STAFF REPORT

PROCEEDING NO. 20I-0437E

IN THE MATTER OF THE INVESTIGATION INTO THE HISTORY AND CONTINUING OPERATIONS OF THE PUBLIC SERVICE COMPANY OF COLORADO COMANCHE UNIT 3 GENERATING STATION PURSUANT TO DECISION NO. C20-0505.

March 1, 2021

*Figure 10. TLO cooler 6-way transfer valve.*³⁷

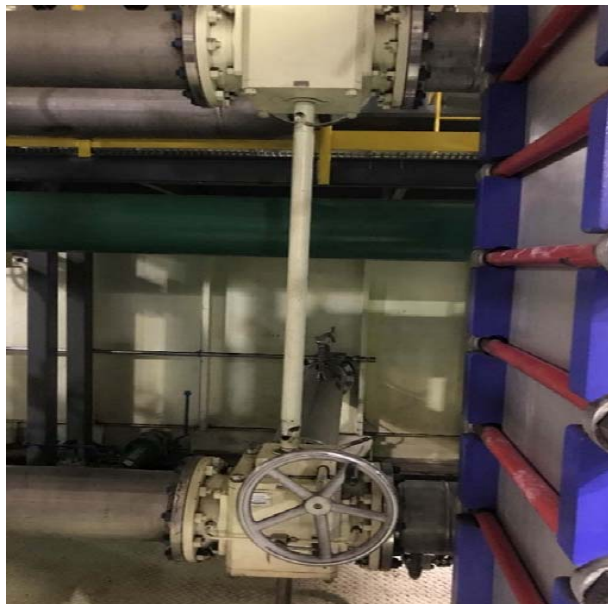
- *Correct TLO Cooler 6-Way Valve Actuator Design.* The turbine lube oil temperature and quality are controlled by regulating the flow of oil through a plate and fin heat exchanger and strainer element. Having clean lube oil at the proper temperature is critical to safe turbine operation. In addition, the criticality of the TLO system necessitates redundancy.

It was noted that the original piping TLO piping design, with a single transfer valve, is contrary to recommended best design practices which recommends that design “[e]nsure the emergency lube oil system configuration is inherently resilient and that no single failure can result in a loss of equipment lubrication. Ensure the emergency oil bypasses coolers and filters and feeds the bearings directly.”³⁶

Consistent with best design practices, most large turbines having TLO systems have two heat exchangers and two lube oil strainers. The piping and valve configurations required to provide this redundancy is complex to design and costly to install. On the Comanche 3 turbine, the original piping designers chose to employ a singular unique valve assembly called a TLO Cooler 6-Way Transfer Valve which is shown below:

the other train to undergo maintenance such as filter changes. Indufil has since been absorbed by John Crane, which no longer supports this particular valve and has classified it as obsolete. Thus, the Company knows it cannot get replacement parts for the TLO Cooler 6-Way Transfer Valve. The Company has no policy with regard to the use of obsolete equipment in the power plant. Instead the Company explains that each piece of equipment is evaluated on its condition and maintainability. If parts are not available, or if repair costs are substantial, then Company will consider replacement of the equipment with an updated design.³⁸

Figure 15. Original P&ID of lube oil system (top) vs. revised P&ID (bottom).

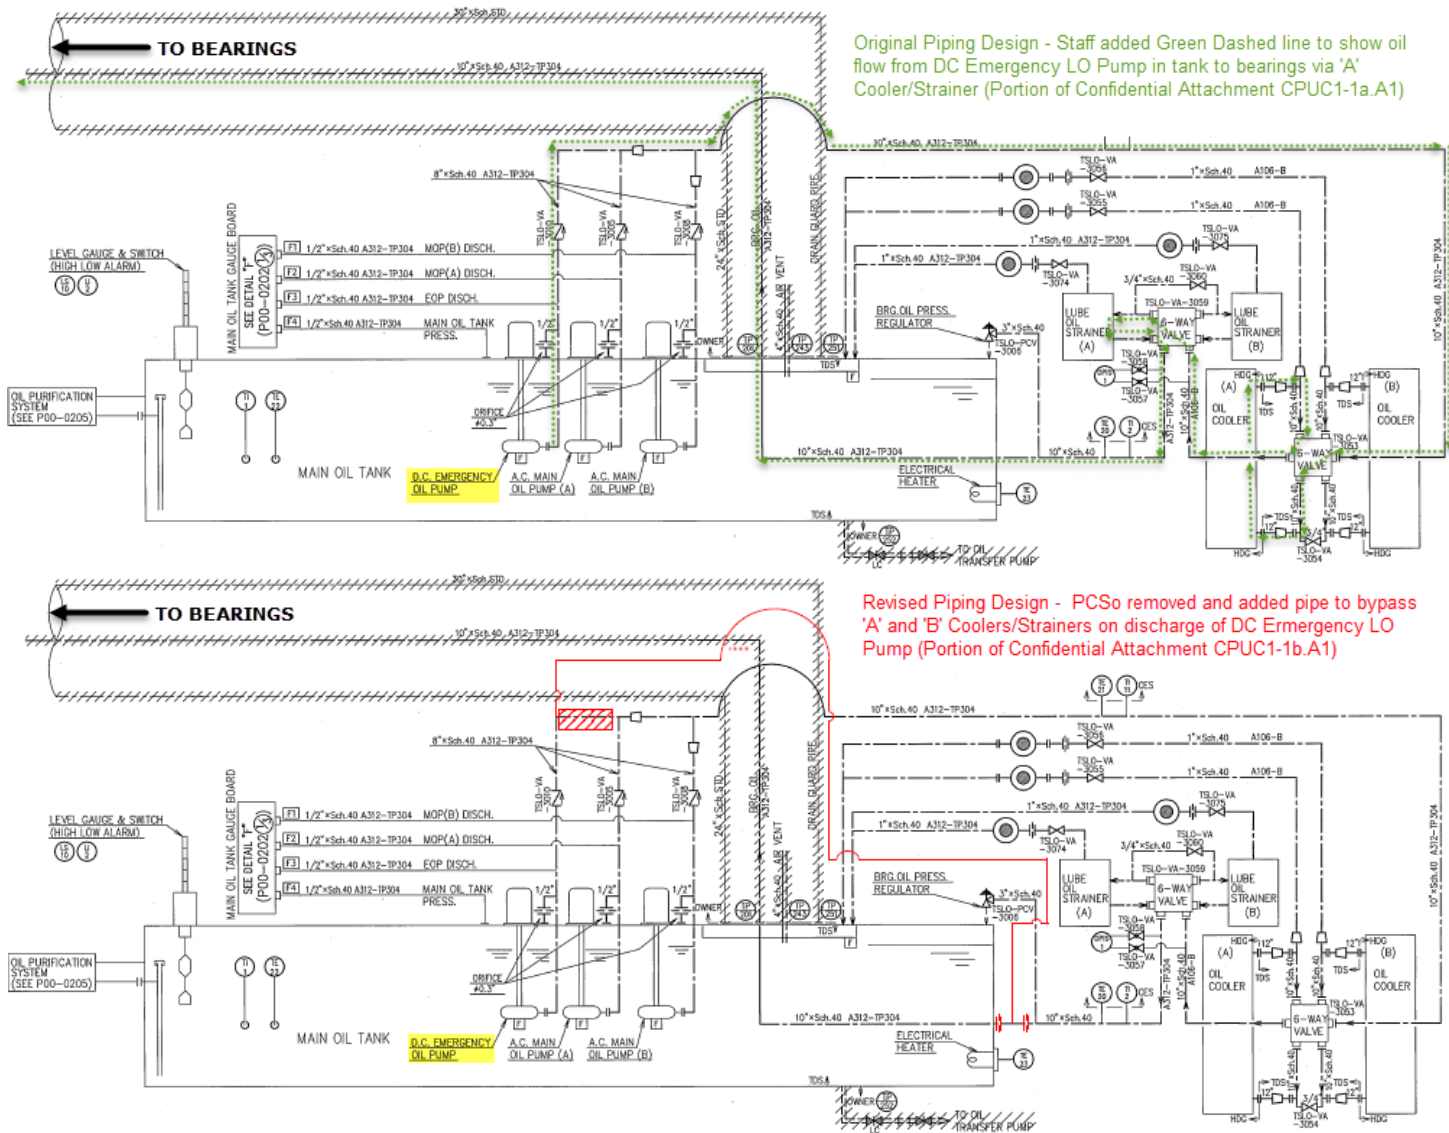
- *TLO Cooler TLO Backup Source.* The TLO Cooler 6-Way Valve was the single point of failure for the June 2, 2020 incident. When the valve stop pin failed, it allowed plant personnel to position valve such that it isolated TLO flow to critical turbine components and also isolated TLO flow from the emergency backup TLO pump.

As mentioned earlier, the original piping design which did not provide the ability for lube oil provided by the DC emergency oil pump to bypass the TLO coolers and filter sets is contrary to industry best practices which recommends

The Technical Design Team, as part of the TLO system corrective actions, removed a section of pipe and added additional piping allowing the DC emergency TLO pump to bypass cooler/filters and feed directly to bearings. Figure 13 illustrates the redlined piping and instrumentation diagram (P&ID) of the system.

Figure 16. Valve sketch (1 of 2).

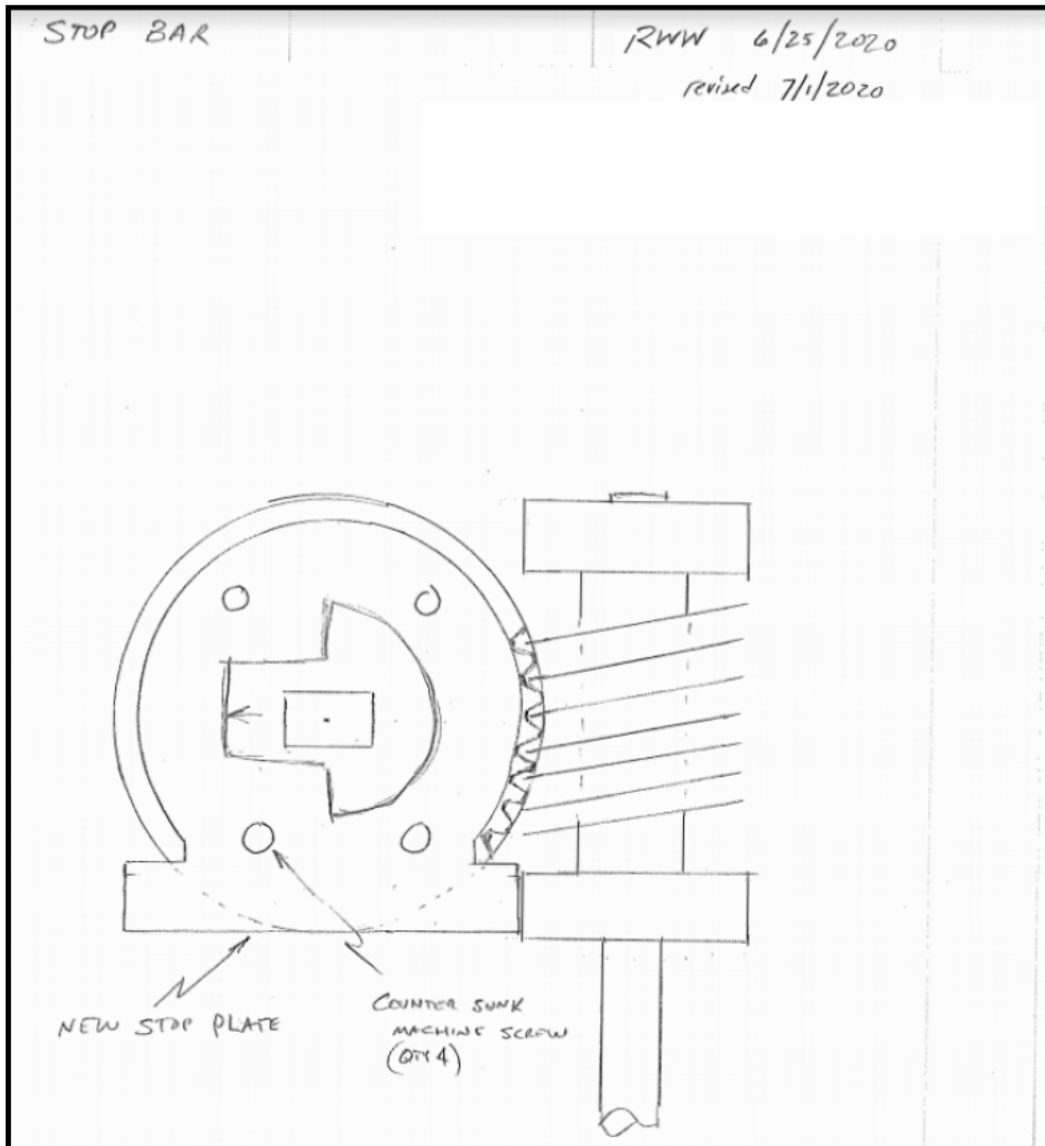
The Company's design modification drawings for the actuator modifications is provided below:⁵⁴

It was noted that the drawings were created and signed by the Technical Improvement Team Lead, who also happens to be the Plant's Manager of Reliability. There was no secondary or independent signature that demonstrated that the design was reviewed or verified. As is apparent by the single signature, design changes appear to have been made also without independent verification. There was no indication of the materials used for the modifications to the valve. There is no discussion of why modifications were made necessary (e.g. the result of a previous incident or identified by a SPOF analysis). There is no indication of what service standard was used, nor was there any indication that the drawings were filed or input into the plant's drawing system for future reference or traceability.

Figure 17. Valve sketch (2 of 2).

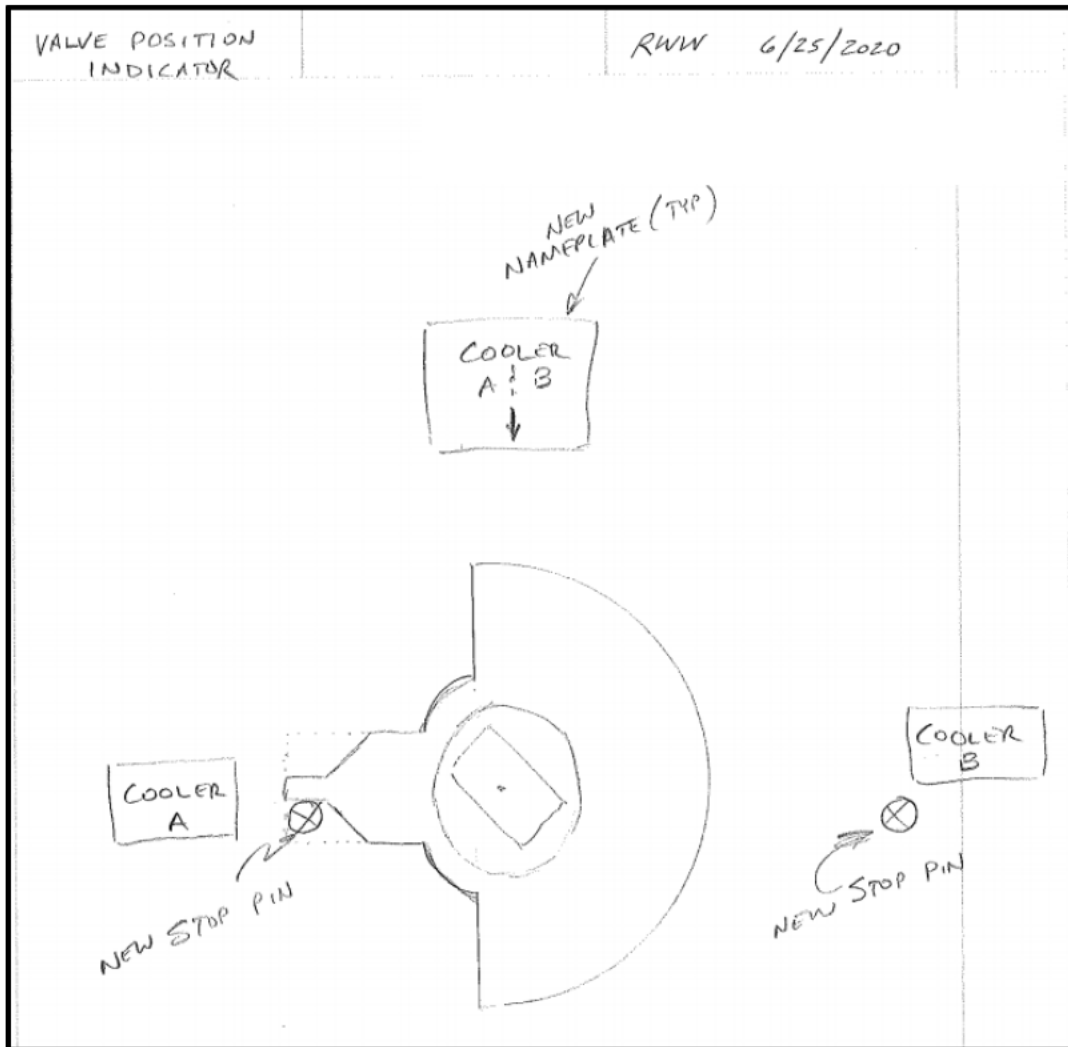
While this is may be a minor design change, it is essential to create a record of what modifications were made and why.
